DRAFT MOTIVATIONAL REPORT

**PART 2 AMENDMENT: AS PART OF THE PROPOSED BOITSHOKO
SOLAR POWER PLANT NEAR KATHU IN THE NORTHERN CAPE
PROVINCE**

DEA Reference No. : 14/12/16/3/3/2/935/AM2

Report Status : Draft Motivational Report

Figure 3.1: Proposed amendments

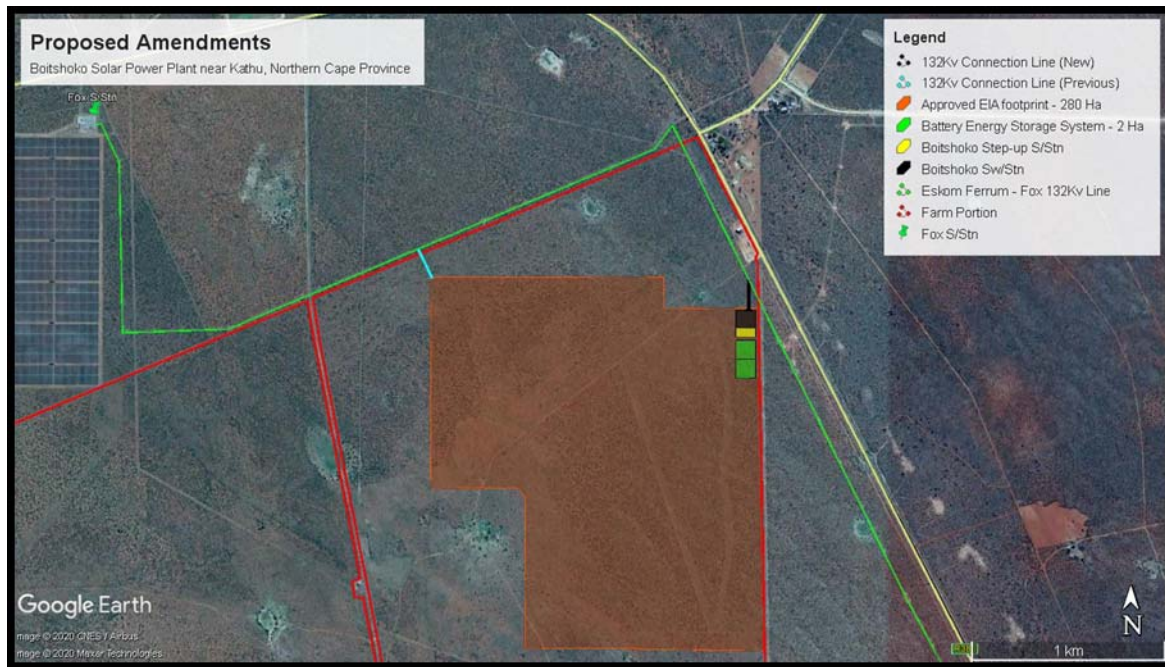
The following amendments are being applied for in terms of the EIA Regulations, 2014 (as amended in 2017)(refer to Figure 3.1):

- Inclusion of a battery storage system

with an area of approximately 2ha. The battery to be installed will be lithium-ion and no electrolytes will be transported to and handled on site. Battery cells will be assembled at the supplier factory prior to delivery to the sites. The battery storage facility will be located within the already authorized PV plant footprint area. There will be no need for the additional clearance of more than 2 ha of vegetation for the development of a new area for the battery storage facility.

Figure 3.3: Substation and switching station (figure for illustration purposes only)

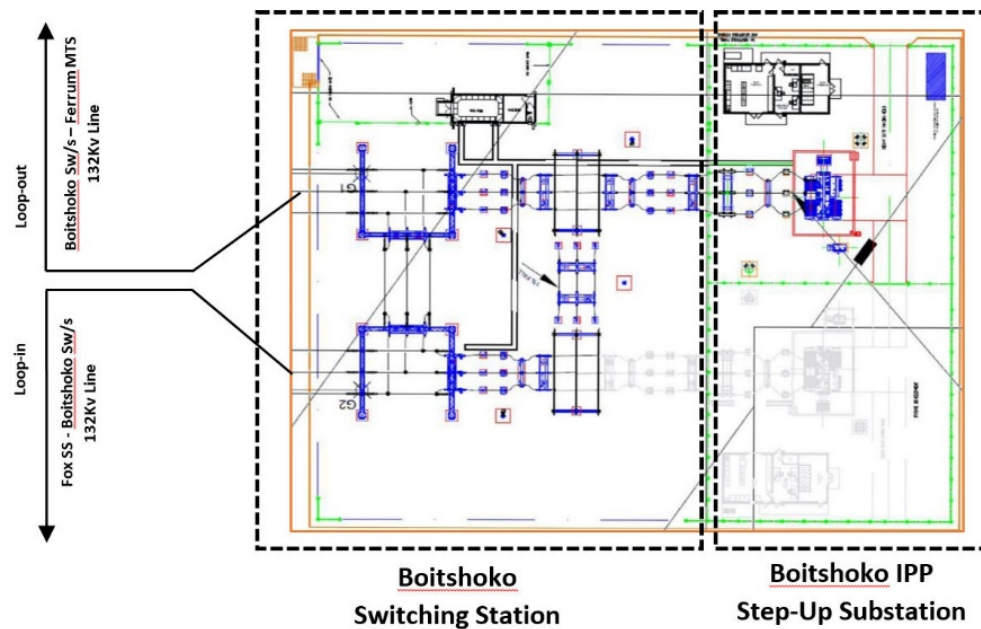
- Increase of Substation footprint and description to accommodate for IPP Step-up Substation and Switching Station

The proposed on site Substation will have a combined footprint of approximately 1.4ha and will consist of an IPP Step-up substation and a Switching Station, the Boitshoko step-up substation will step-up the generated capacity to 132Kv in order to connect and supply at the same Voltage as the existing grid, the Switching Station will be the connection between the Step-up Substation and the Existing Ferrum – Fox 132Kv Line (refer to figure below). The proposed connection line will therefore be constructed using Loop-in Loop-out line between the Boitshoko Switching Station and Ferrum – Fox 132Kv Line.
